**ADDENDUM NUMBER (1) One
IFB-20-PW-020
Industrial Park Loop Improvement Project**

April 23, 2020

Addendum Number (1) One forms part of the contract documents and modifies them in the manner set forth below.

Standard Trench/Embankment Installation

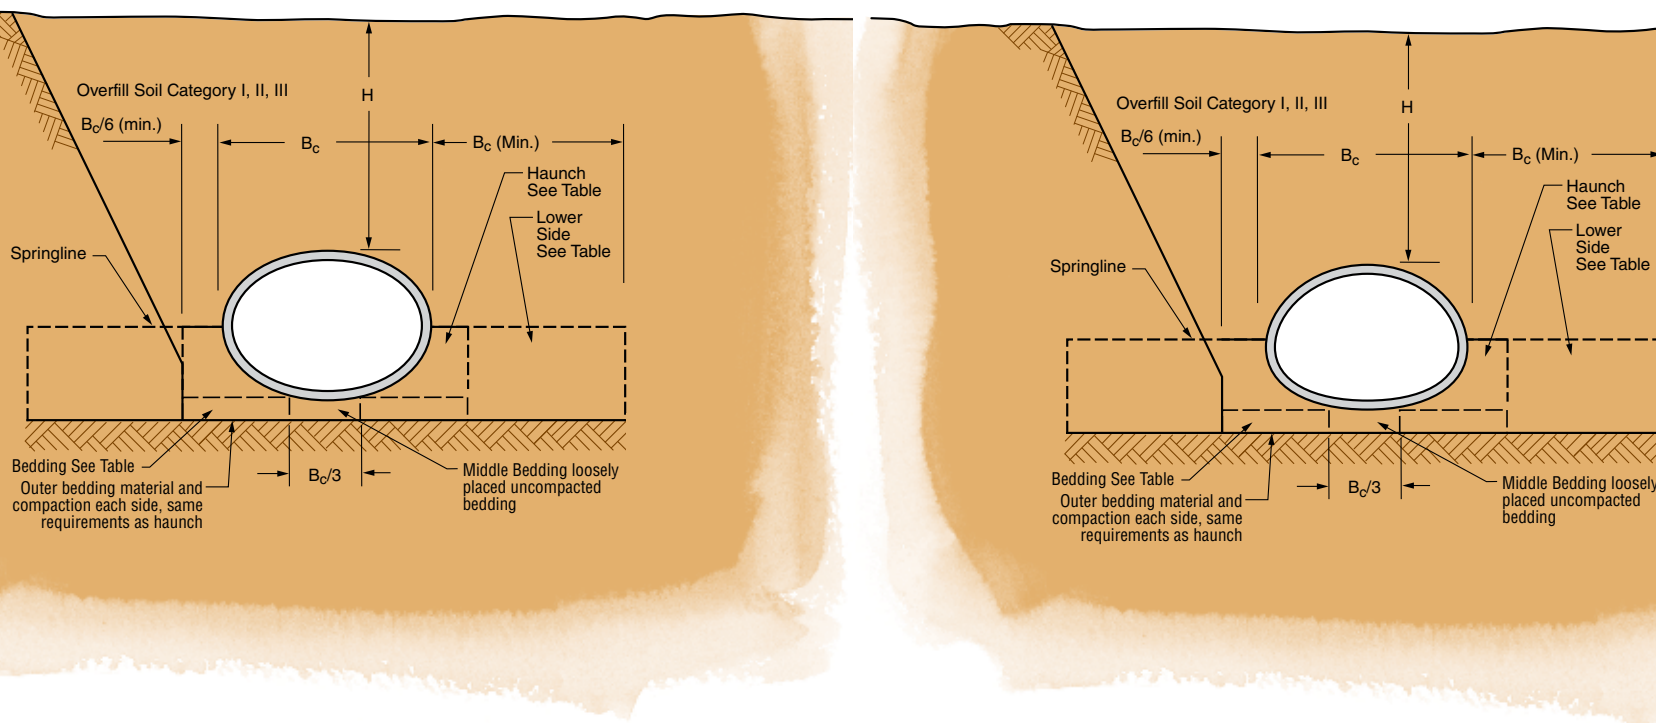
32) Question: Is there a special bedding/backfill required for the elliptical RCP?

Answer: Yes, please see Attachment 2 included with this Addendum.

Concrete pipe should be installed in accordance with the AASHTO LRFD Bridge Construction Specifications, Section 27 or ASTM C1479. Figure 1 shows the basic pipe and soil terminology.

There are two types of Standard Installations for horizontal elliptical and arch concrete pipe, each with its own soil and compaction requirements. Type 2 bedding provides better support using well compacted granular material, while Type 3 provides for less support allowing the use of silts. These choices provide flexibility and versatility for the designer and contractor, as well as performance and economy for the owner that are not available with other types of pipe.
